Technical Service Information

CHRYSLER A604 REVISED LOW/REV PISTON SEALS

Figure 1

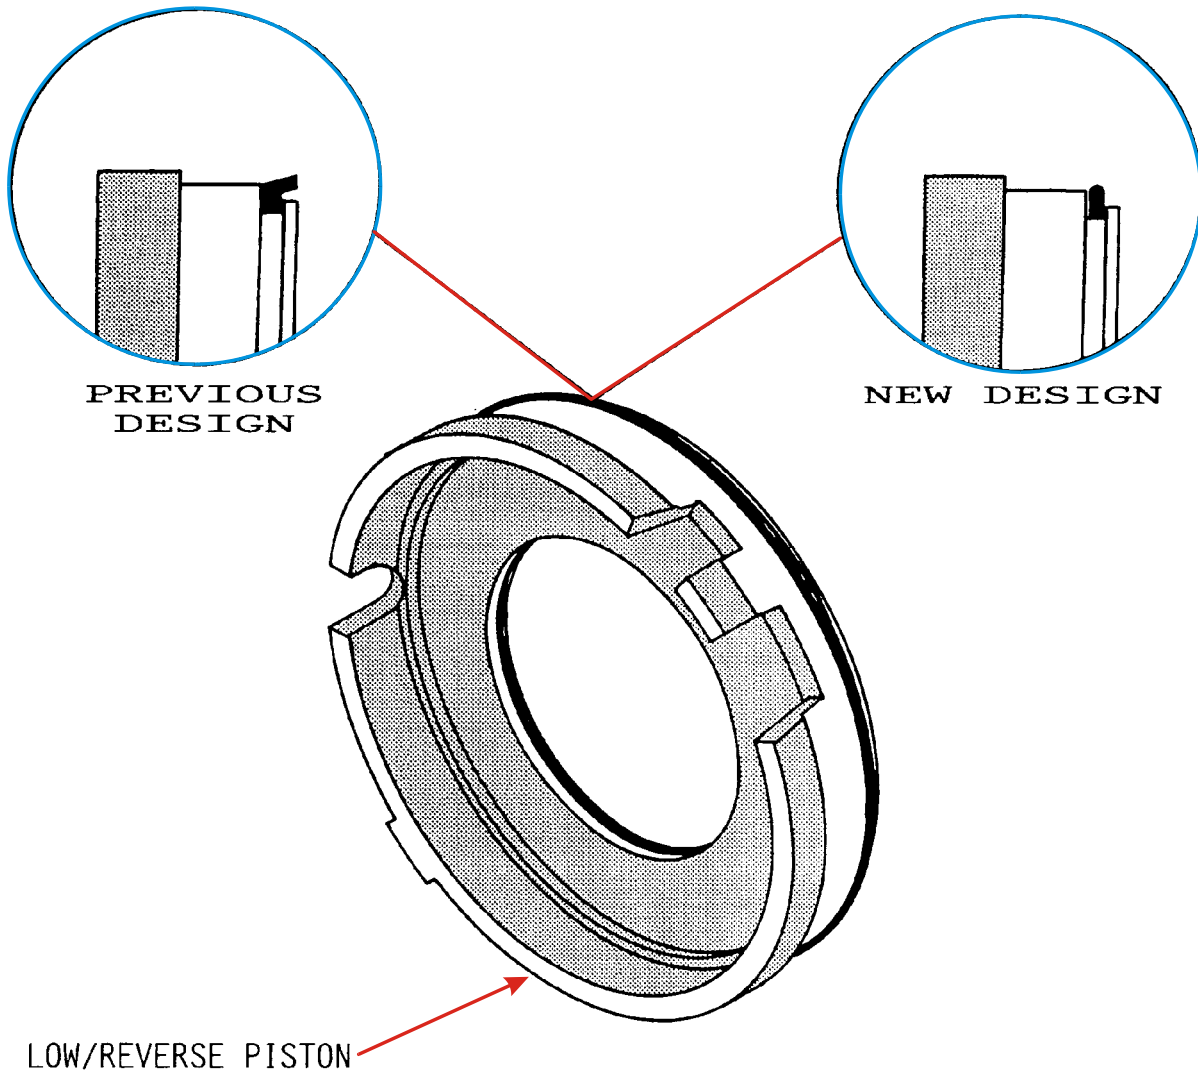
CHANGE: Beginning at the Start Of Production for 1995 model year, all Chrysler A604 (41TE) and A606 (42LE) transaxles were produced using revised seals for the Low/Reverse piston. The previous "Lip" type seals have been replaced by a "D" Ring type seal for both inner and outer seals, as shown in Figure 1.

(1) LOW/REVERSE PISTON SEALS - Both the inner and outer lip seals have been replaced by a "D" Ring type seal, as shown in Figure 1. There were no dimensional changes necessary to the Low/Reverse piston to accommodate the new "D" Ring seals. The seals are available under OEM part number 4659185 for the outer seal, and 4659184 for the inner seal.

The new "D" Ring type seals will back service ALL previous models of the Chrysler A604 (41TE) and A606 (42LE) transaxles, without any additional modifications or changes.

Low/Reverse Piston Outer Seal ("D" Ring) 4659185
Low/Reverse Piston Inner Seal ("D" Ring) 4659184
